#### 183rd session

## Proposal for Supplement 3 to the original series of amendments to UN Regulation No. 149 (Road illumination devices)

### Submitted by the Working Party on Lighting and Light-Signalling\*, \*\*

**Passing beam test points and zones for Class BS headlamp(s)**

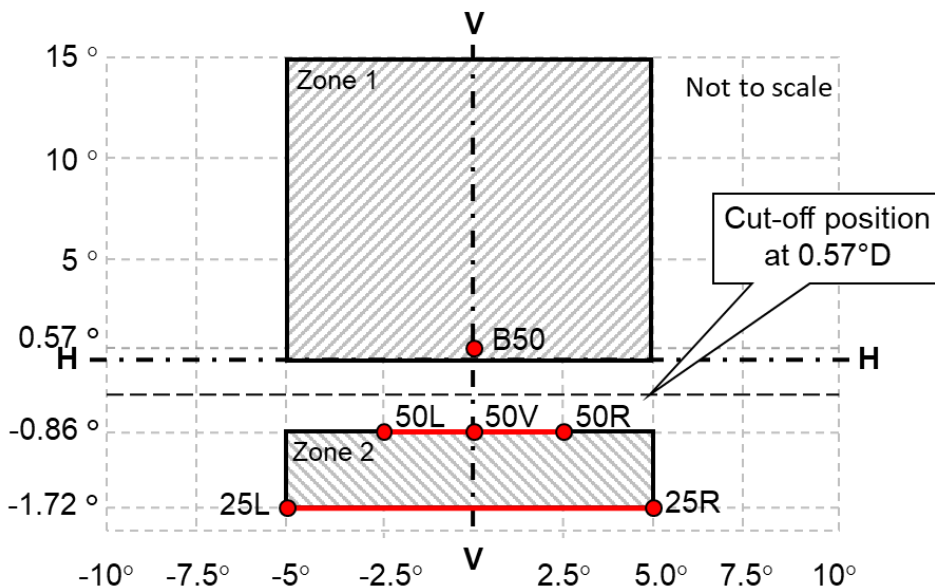
Figure A4-IX; amend to read:

## "Arrangement of approval marks

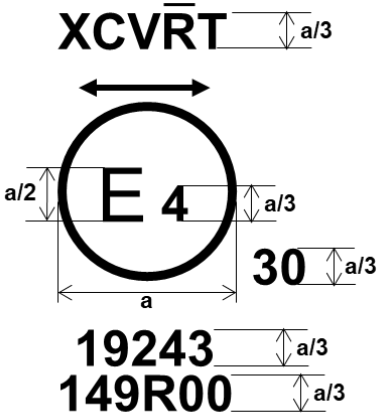
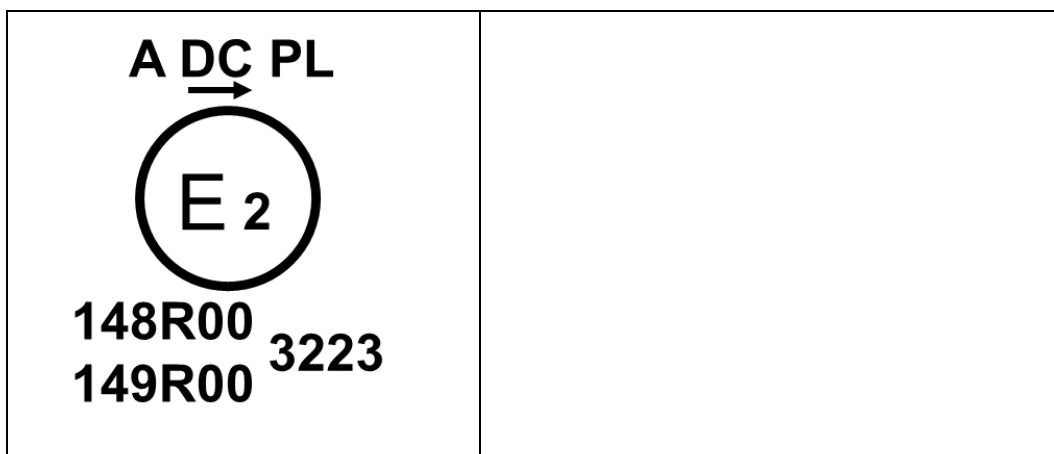
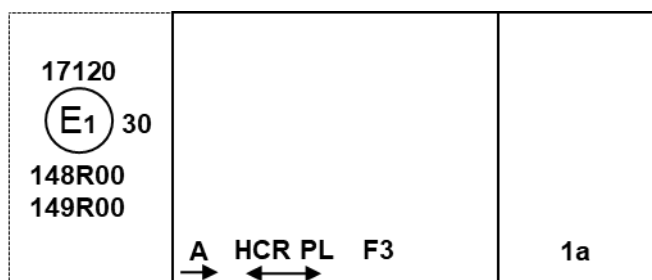
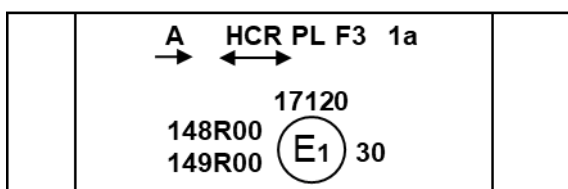
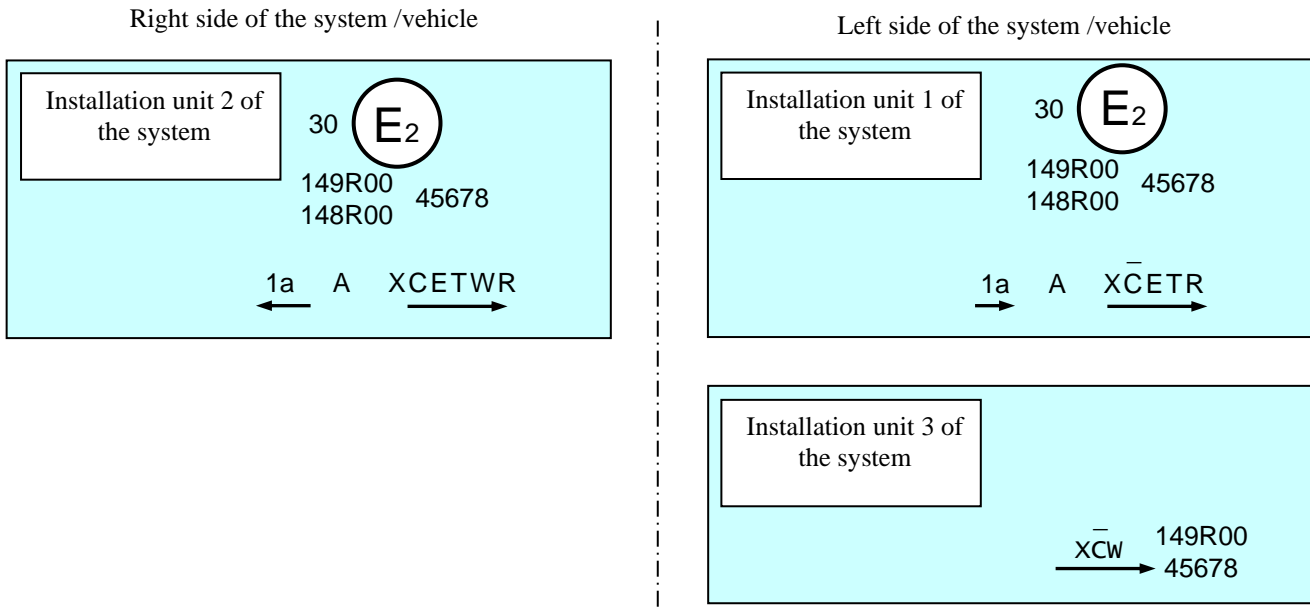
Annex 13, amend to read:
